TECHNICAL BULLETIN

TRAILER AIR SUSPENSION NEW TRI-FUNCTIONAL² II BUSH IMPROVEMENT

No: TRAILER AUS-008
Subject: *Product Update*
Date: August 1997 **Revision:** A

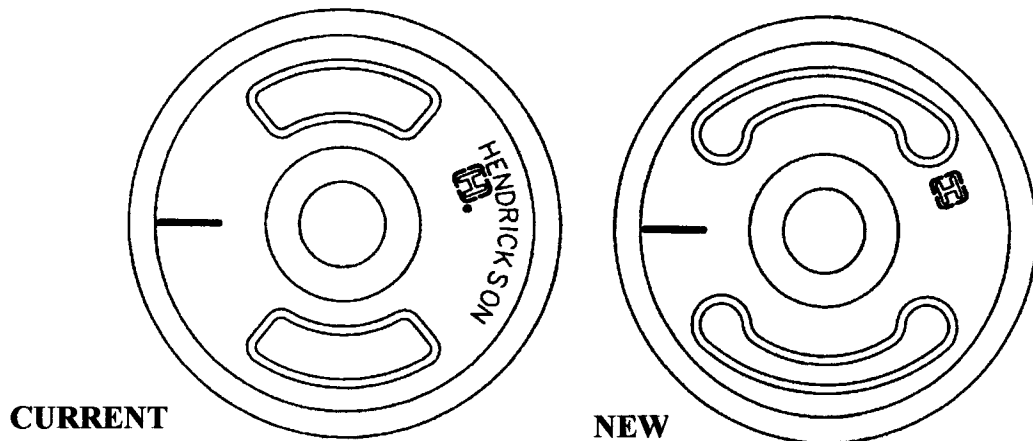
As part of our continuous product improvement efforts, Hendrickson Trailer Suspension Systems is introducing the new Tri-Functional II Bushing (Part No. C-21824) for all suspensions. The Tri-Functional II Bushing extends the bushing life by incorporating a change in the configuration of the void area, while keeping material composition the same. Fitment of the new bushing (pictured above) will remain the same as the current Tri-Functional Bushing (Part No. C-3558). Phase in of the bushing to product line is as follows:

The new Tri-Functional II Bushing and the current bushing should not be mixed on axle positions. Bushings should be replaced by axle sets.

All current bushing kits will be changed to include the new Tri-Functional II Bushing, but the kit numbers will remain the same.
